**Re: TOWN OF VIRDEN WWTF - NEW EAL
NOTICE OF ALTERATION REQUEST**

In accordance with the Environment Act (Section 14), this submission is a request for a minor alteration to the new Licence being prepared for the Town of Virden Wastewater Treatment Facility (WWTF).

Virden BOD Results

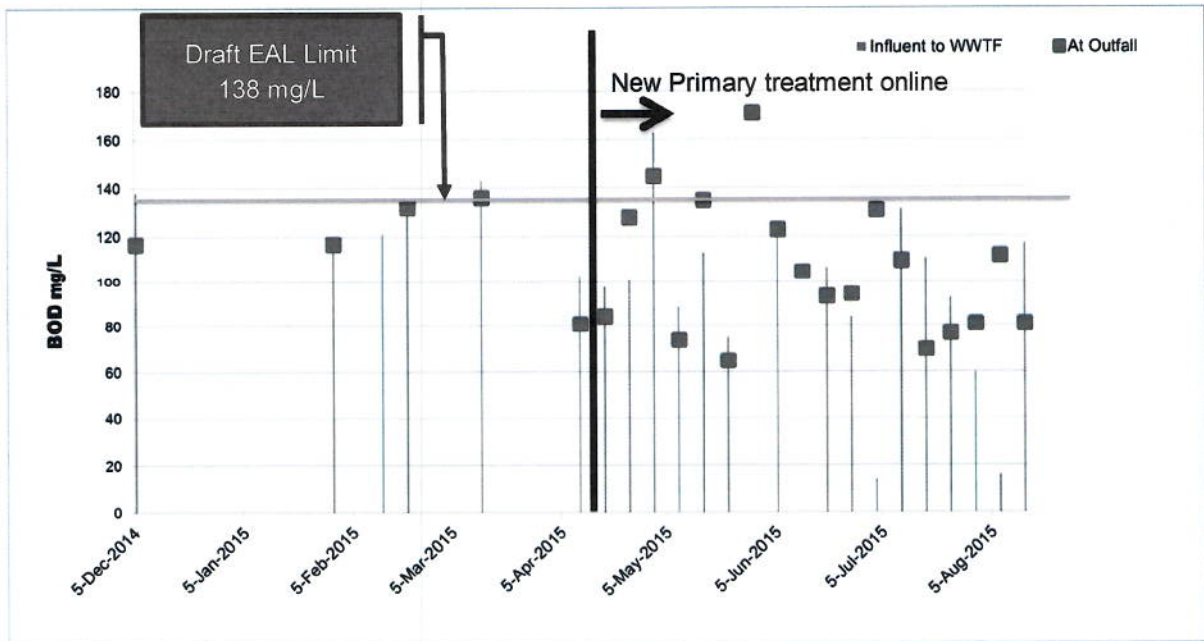
As additional information, included are the lab summary results from December 2014 through to August 2015. The results show that in general the new primary treatment process is performing as expected with a moderate reduction in TSS and a minor reduction in BOD through the process.

Viriden Fecal Results

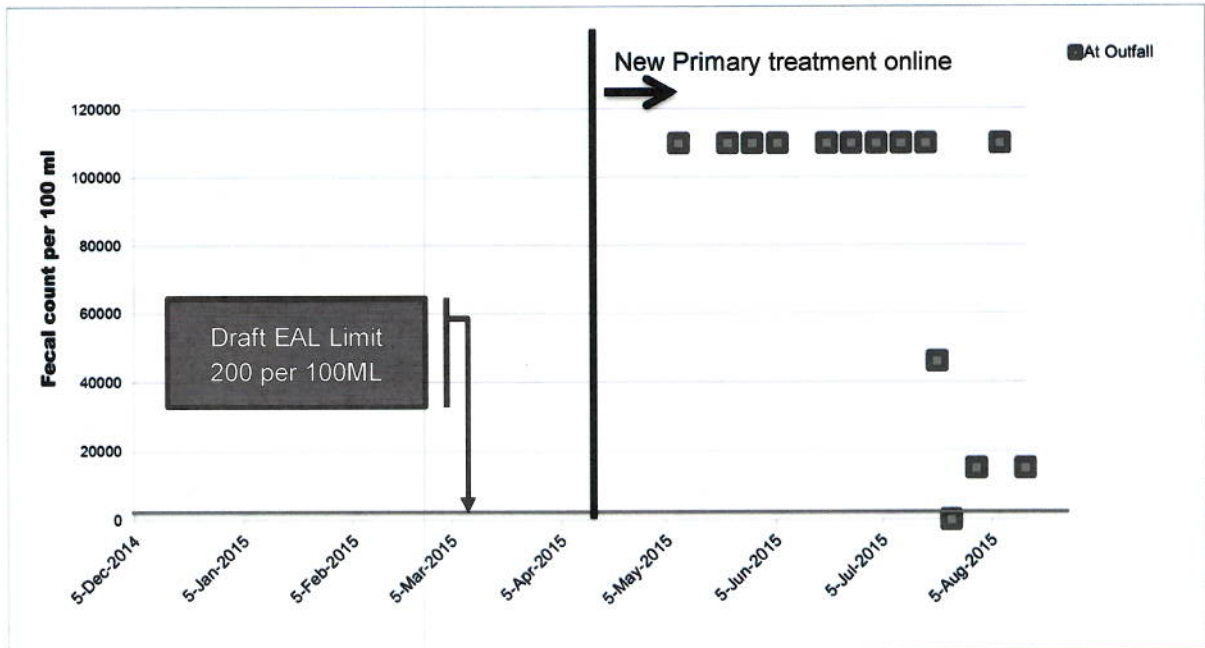
Over the last several months the Town has been trying to increase chlorine dosage to reduce the fecal coliform content of the effluent. At one point they were dosing nearly two 250L barrels per day and the fecal concentration was only reduced to 15,000 to 20,000 per 100 ml. Although there is a sodium bisulfite feed to de-chlorinate prior to the outfall, the Town was concerned with dosing this amount of chlorine into the effluent. It does not seem feasible for the town to achieve the 200 per 100 ml MPN limit with chlorine at this time given that they only have primary treatment in place.

Given that this is only primary treatment, there is no reduction in pathogens to be expected through the Salsnes; this will need to be treated through chlorine addition. The amount of chlorine required to provide sufficient pathogen kill (<200 MPN) is extremely high and concerning to the Town. As the flowing charts show, the Fecal count was reduced to near 230 MPN at one time, but at the cost of two sodium hypo barrels per day. The Town feels this amount of chlorine, even when suitably countered with de-chlorination, can be more harmful to the environment than the elevated Fecal counts. Thus they are currently dosing a barrel every one to two days.

The Town and MB Conservation will likely need to have further discussion on this issue. With the announcement of funding for Phase 2, it is anticipated that the full treatment system will be in place by early 2017, and the new system will then meet the disinfection targets.
